Ref: P4380/L02/RDC (email attachment)

23a Crimsworth Avenue – Acoustic Design Review

External Wall Construction

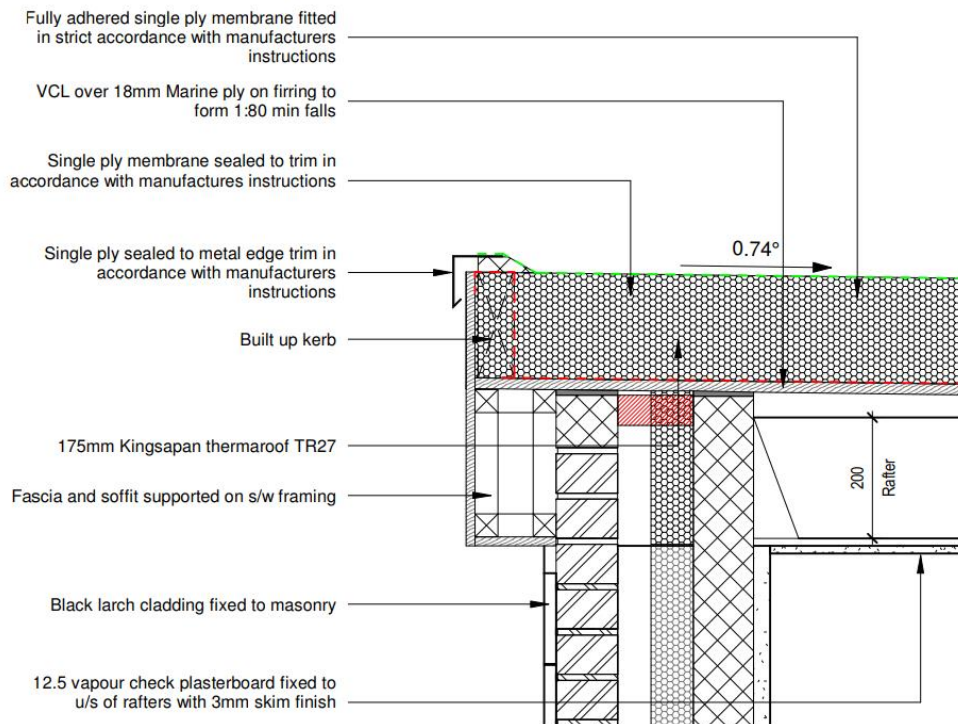
This wall construction would be expected to achieve a sound insulation performance of approximately 55dBR_w. Therefore, meeting the requirement of approximately 50 to 55dBR_w on-site.

Pitched Roof

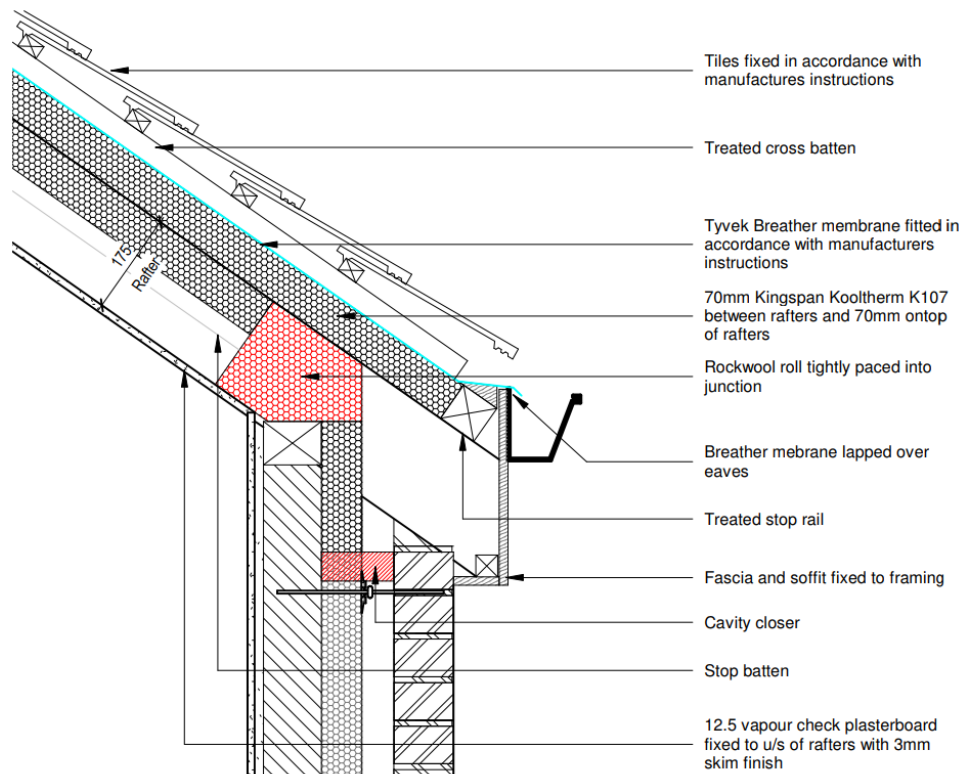
Calculations indicate that this roof construction would achieve a sound insulation performance that does not meet the requirements. We would recommend installing mineral wool with a density of 22kg/m^3 and a ceiling should be comprised of two layers of 12.5mm thick Gyproc SoundBloc.

In order to achieve the requirements, the proposed ceiling must be removed and two layers of 12.5mm thick BG SoundBloc installed via resilient bars to the timber rafters. Within the cavity formed by the rafters, 50-100mm thick mineral wool should be installed.
